DESCRIPTION OF PROPOSED CHANGES
NPF-10-50 AND NPF-15-50, REVISION 2²⁵
AND SAFETY ANALYSIS

This is a request to revise Technical Specification 3/4.9.6, REFUELING MACHINE.

DESCRIPTION OF PROPOSED CHANGE NPF-10/15-52 AND
SAFETY EVALUATION

This is a request to revise Technical Specifications 3/4.2.4 and 3.3.1 (Table 3.3-1, Action 6) and associated bases.

Figure 3.2-2

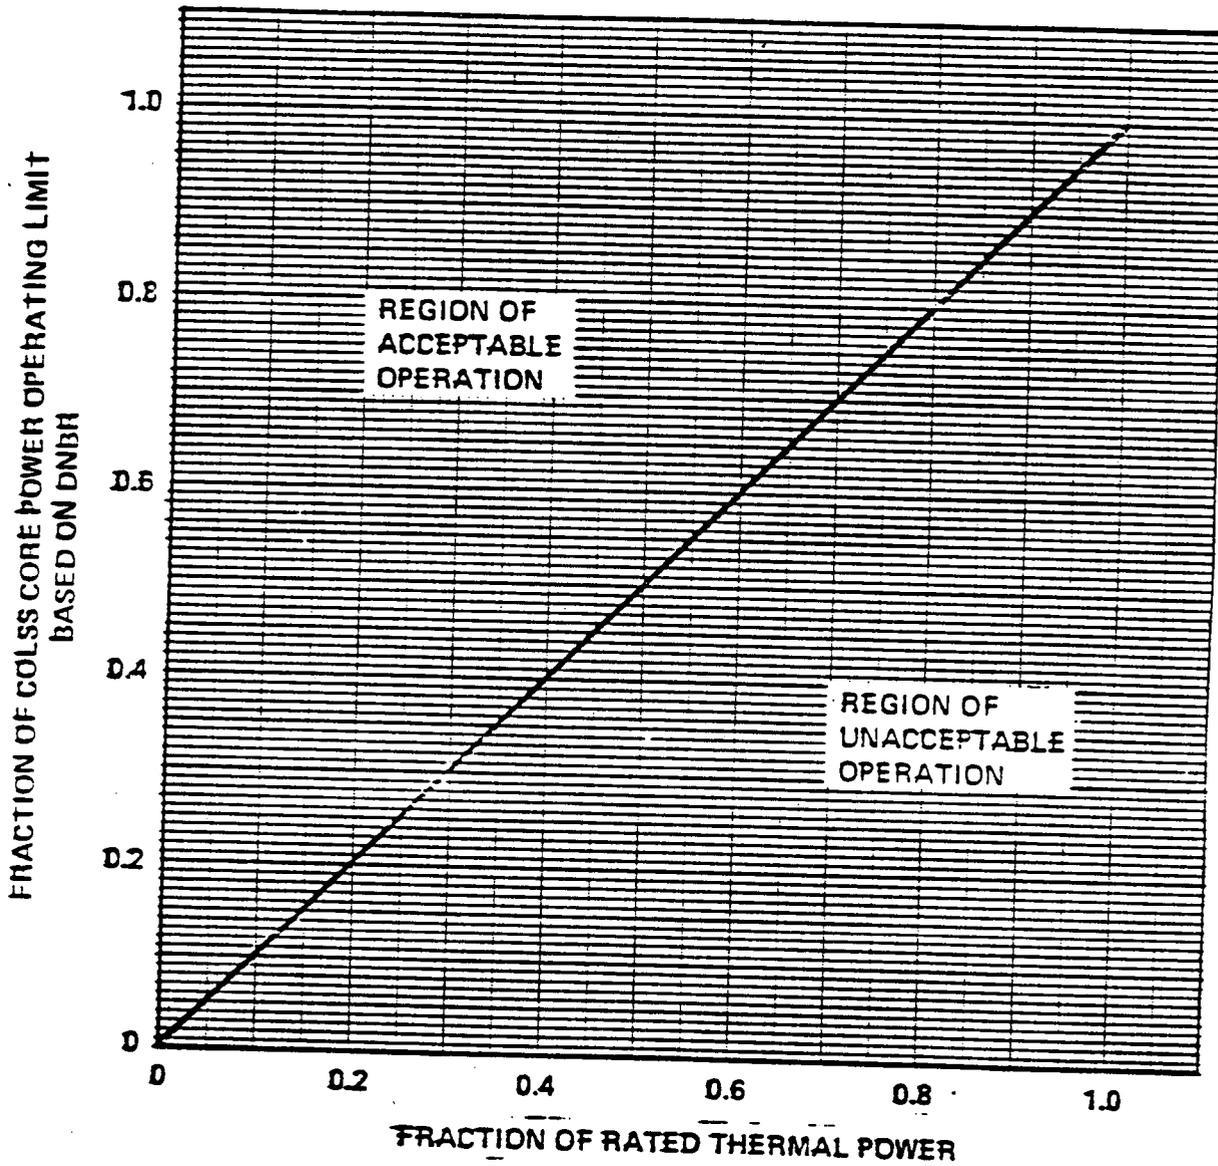
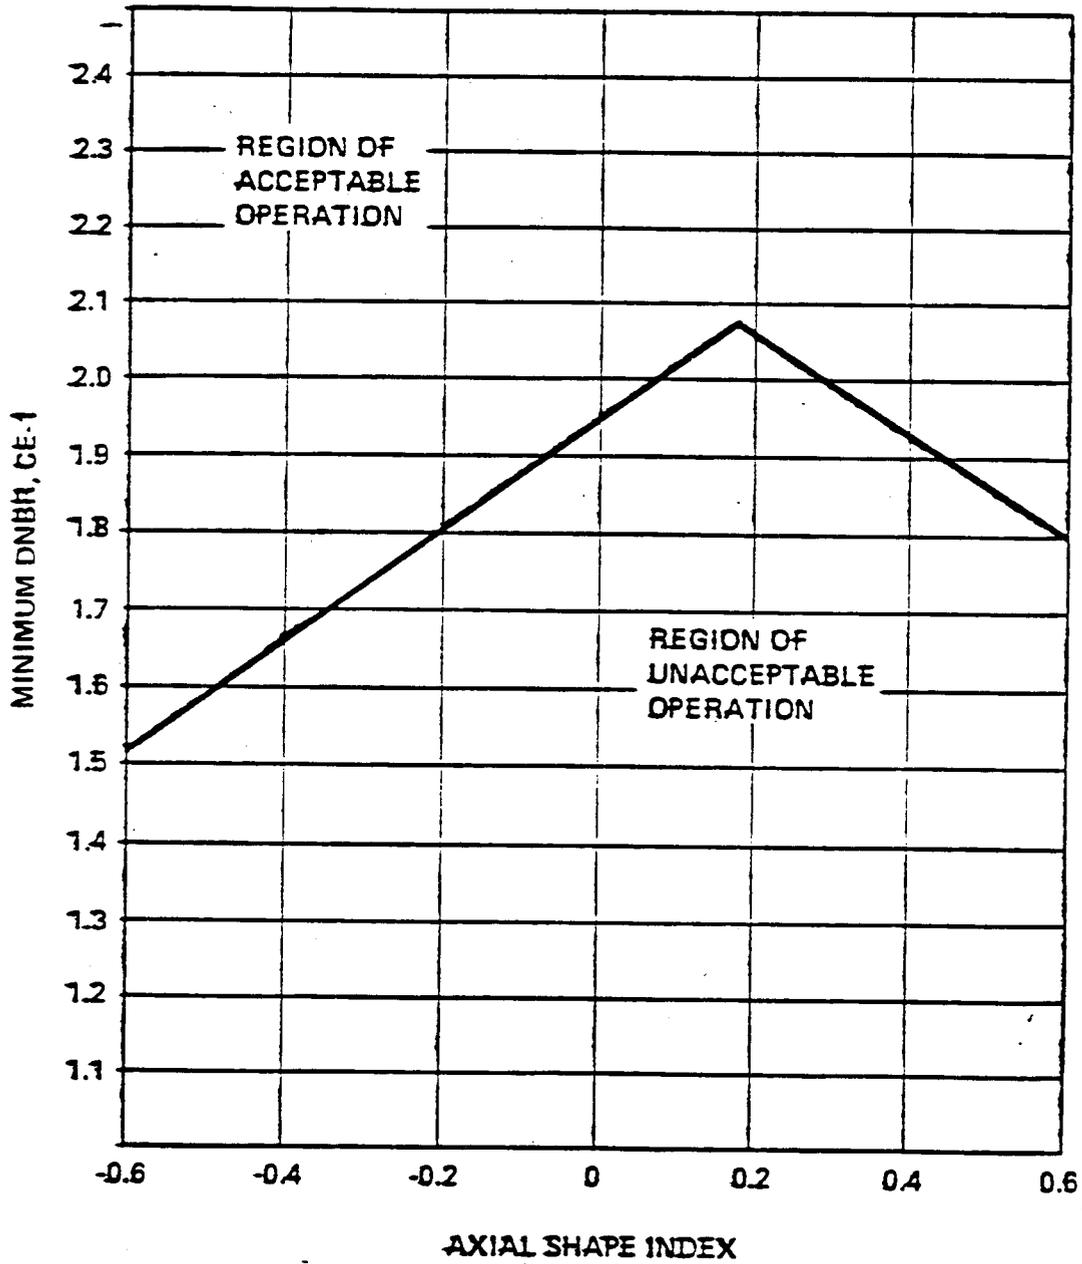
The COLSS reserves the Required Overpower Margin (ROPM) to account for the Loss of Flow transient which is the limiting AOO. When the COLSS is Out of Service (COOS) the monitoring function is performed via the CPC calculation of DNBR in conjunction with a COOS Limit Line (Technical Specification Figure 3.2-2) which restricts the reactor power sufficiently to preserve the ROPM.

This proposed change increases the COLSS out-of-service margin by 10%. The thermal margin gain is reflected in the new COLSS out-of-service limit lines as presented in revised Figure 3.2-2 and new Figure 3.2-3 of Attachment B. These lines take into account a reevaluated CPC overall uncertainty consistent with the requirements of LCO monitoring.

Figure 3.2-2

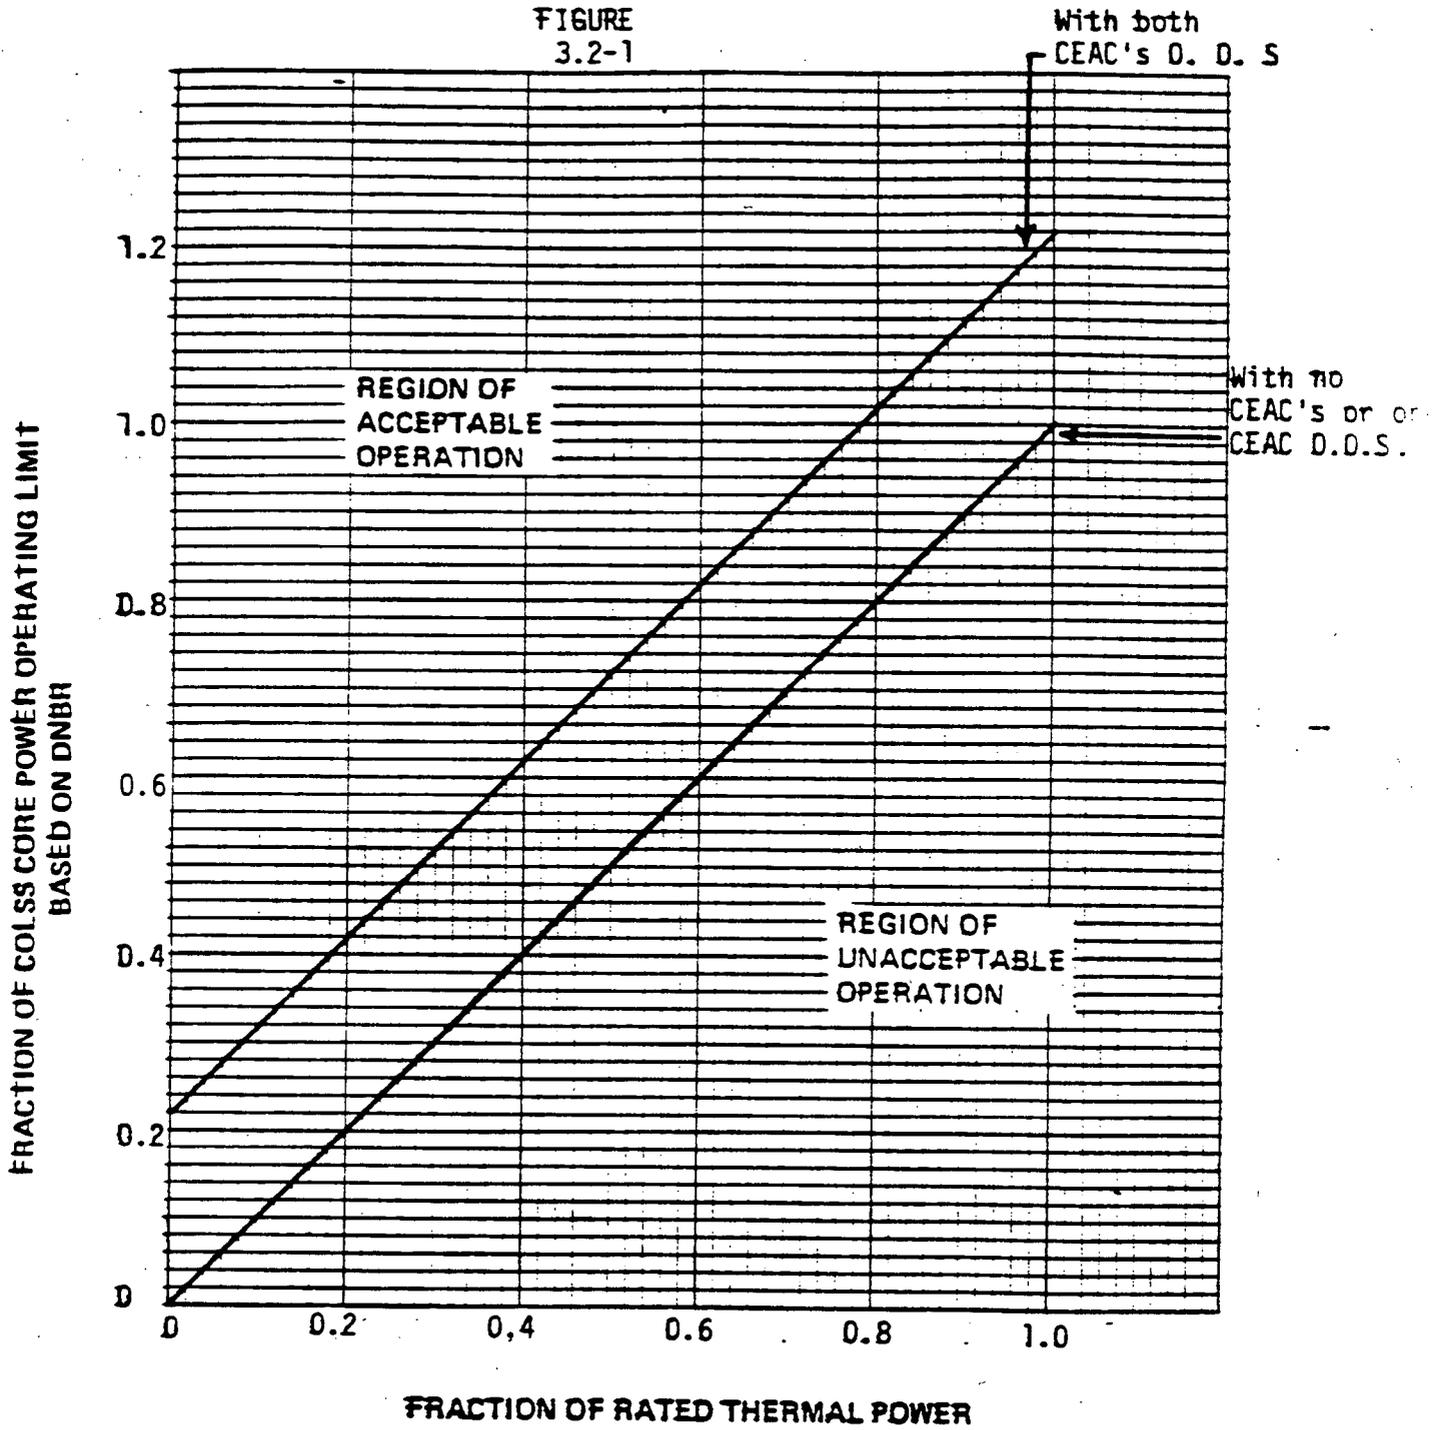
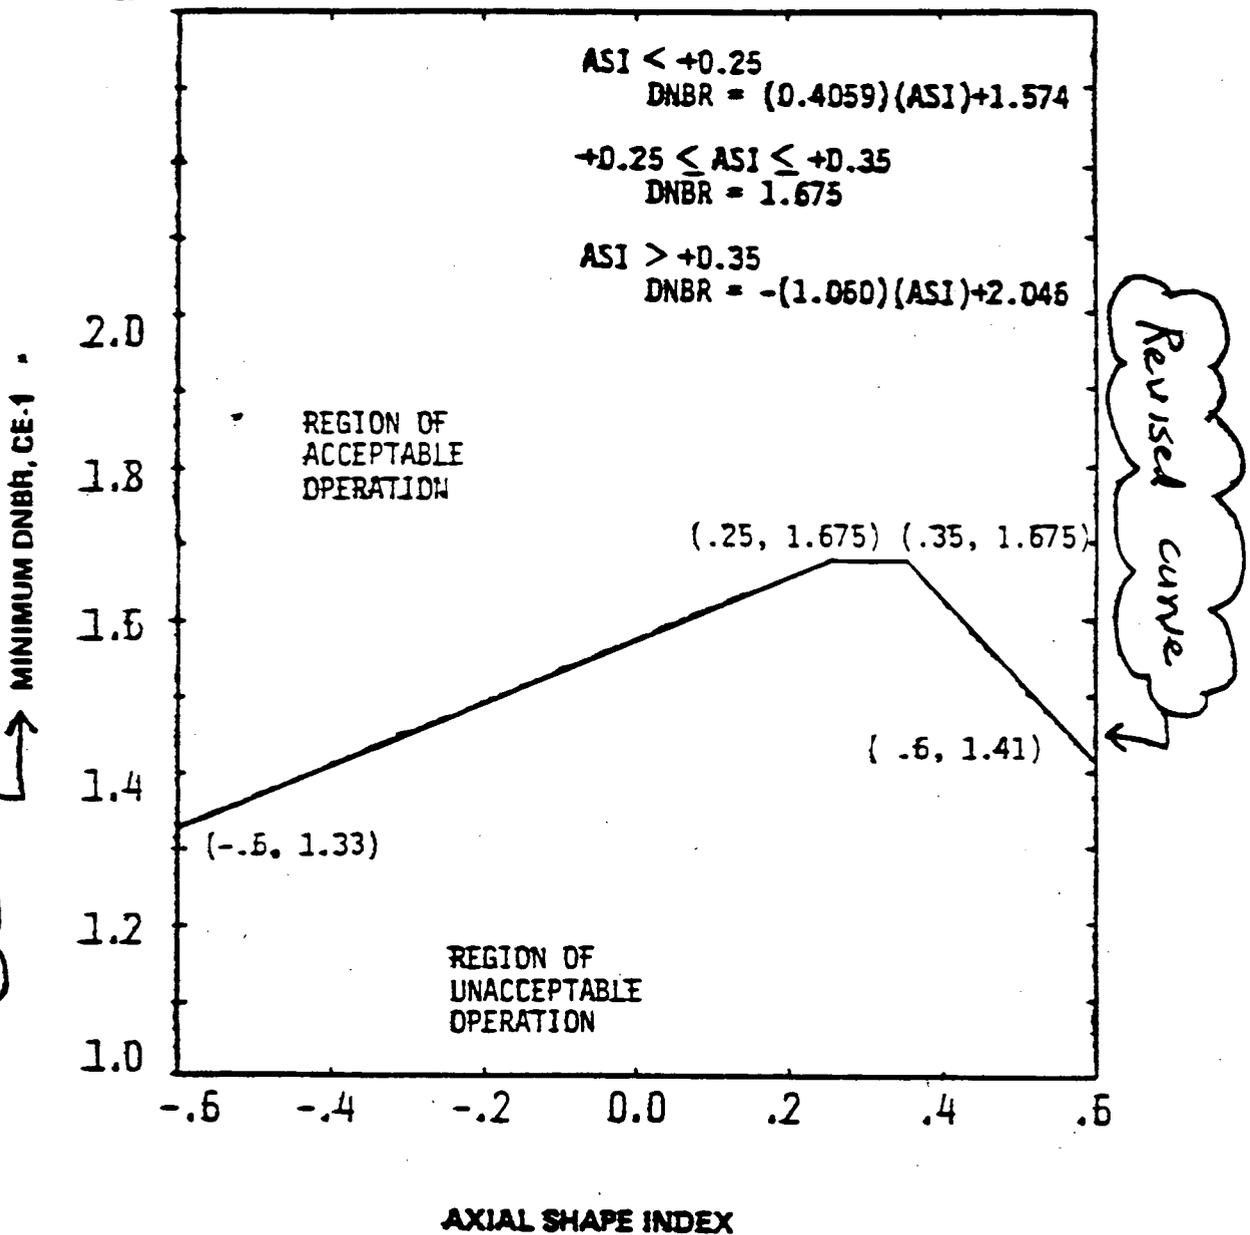
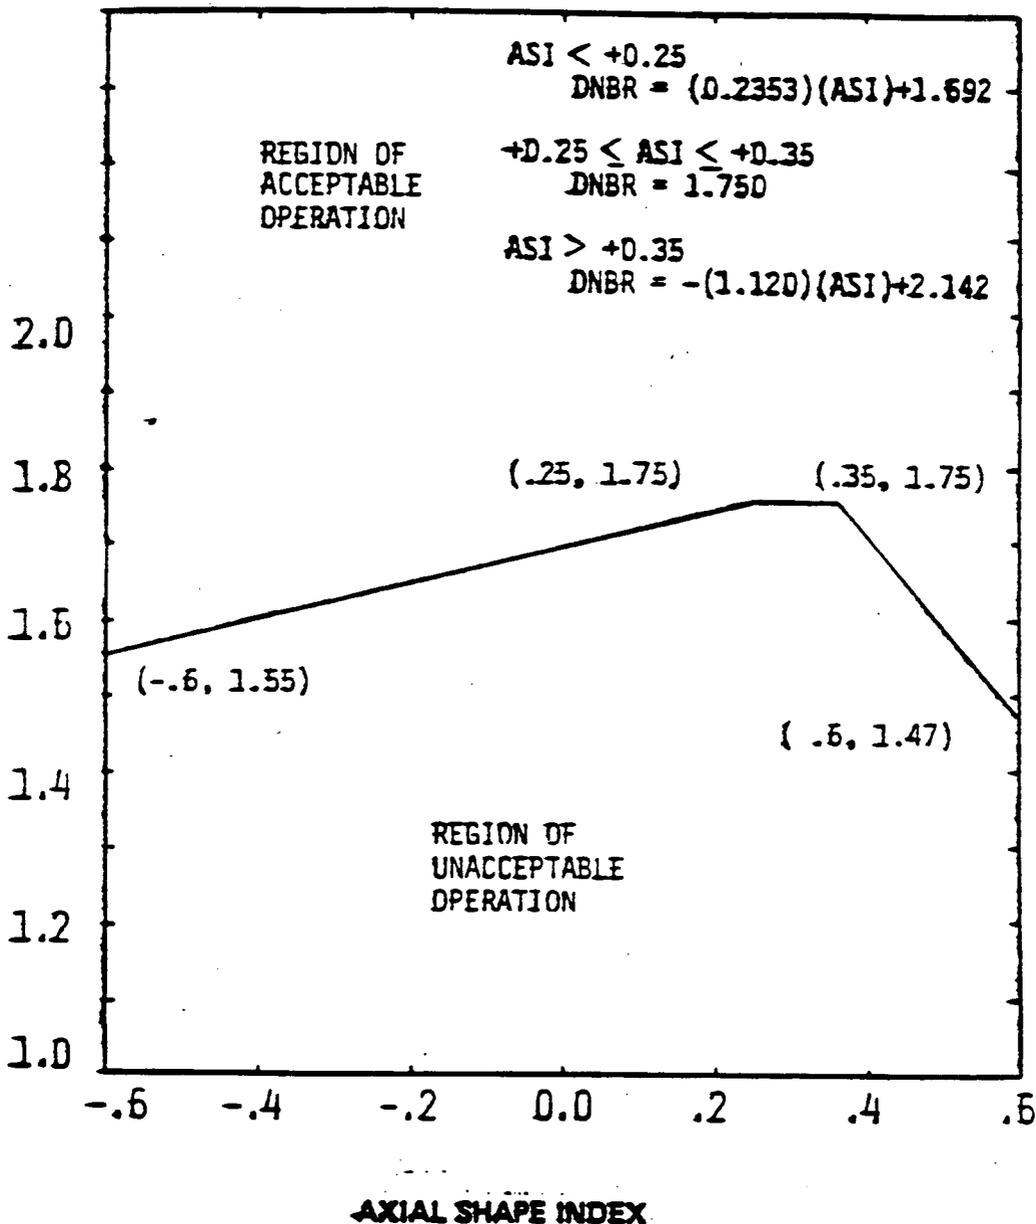
Add: with RATED THERMAL POWER $\geq 80\%$.

change to: 3.2-3

Add: CPC

Change to: 3.2-3

Add: with RATED THERMAL POWER < 80%.

Figure 4.4-1
TUBE WALL THINNING ACCEPTANCE CRITERIA

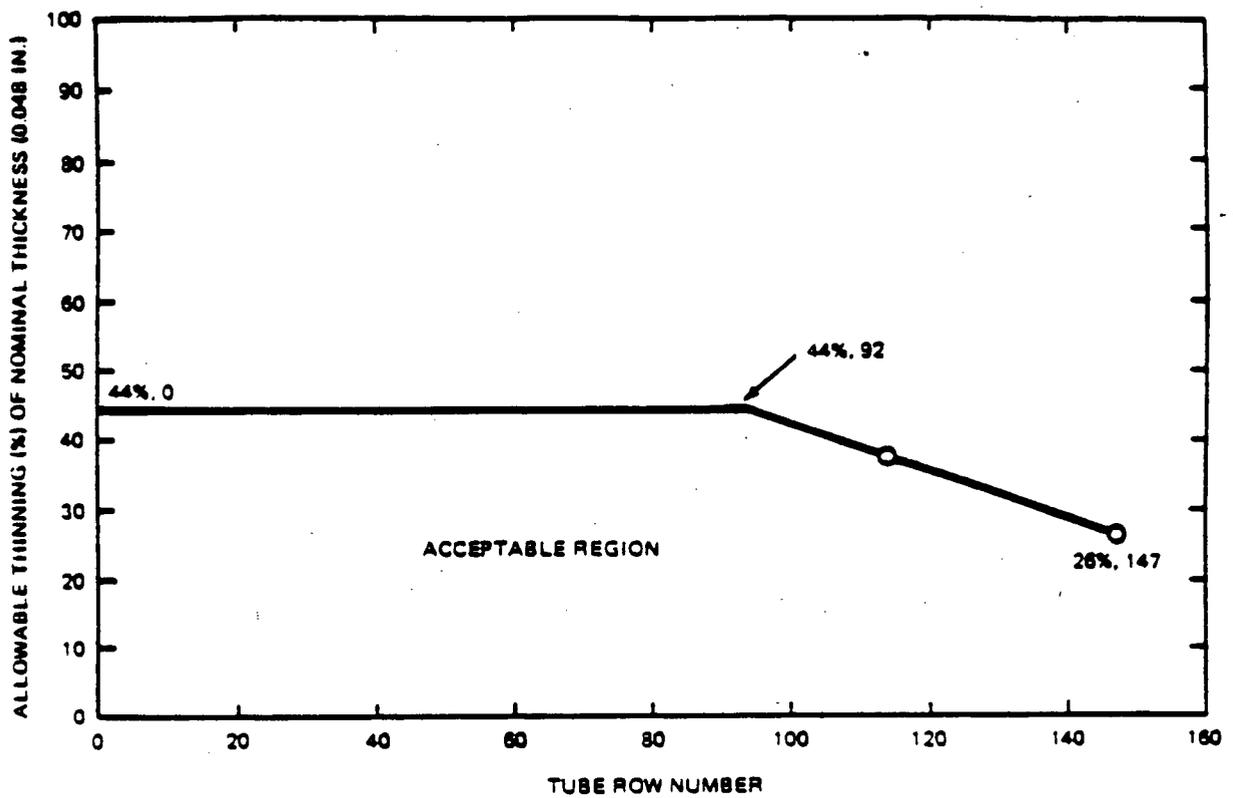
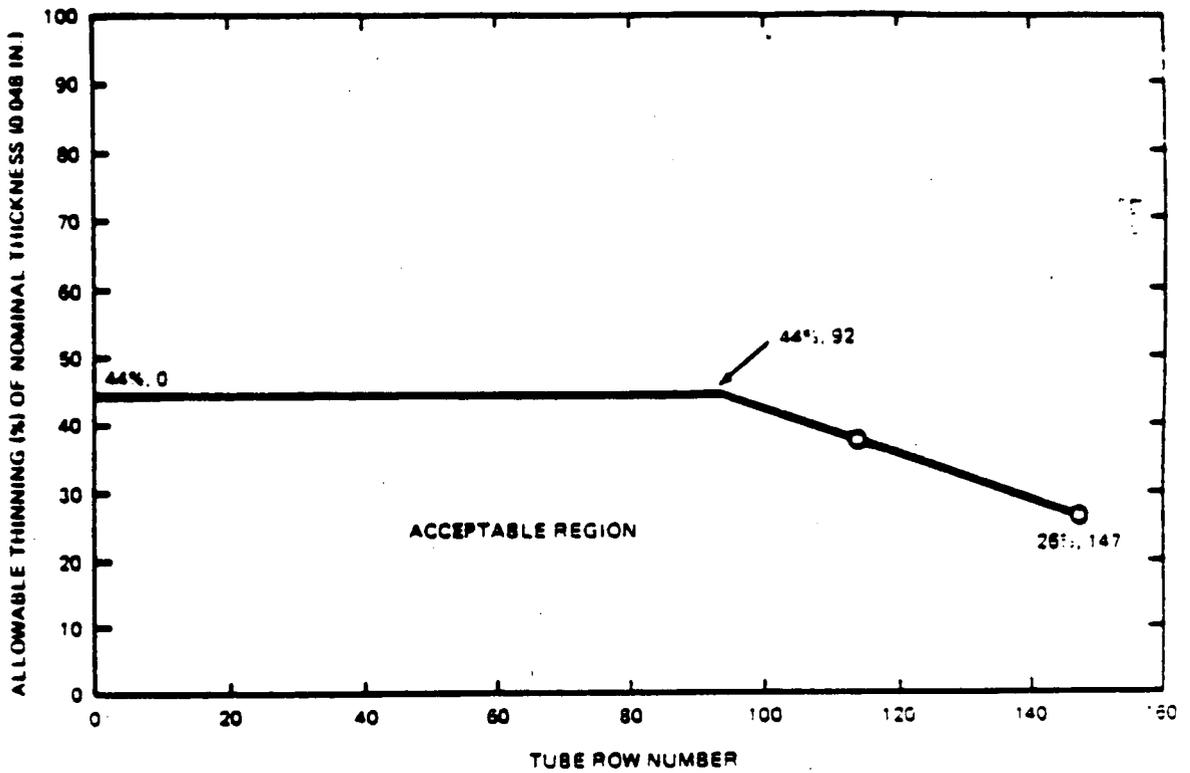
Technical Specification 3/4.4.4 requires steam generator operability and specifies Surveillance Requirements to verify steam generator integrity. The current acceptable level of steam generator tube wall thinning shown in Figure 4.4.1, is 44% for tube rows 0 through 92 and decreases linearly to 26% in tube row 147. The proposed change will delete Figure 4.4.1 and specify a tube thinning limit of 44% for all steam generator tubes.

In establishing the Technical Specification limits for San Onofre Units 2 and 3, the NRC imposed a 20 percent reduction in the above allowable degradation to cover Eddy Current Testing (ECT) measurement error and continued degradation through the next fuel cycle (in response to guidance provided in Regulatory Guide 1.121). As a result, a steam generator tube degradation limit of 44 percent for all steam generator tubes is proposed.
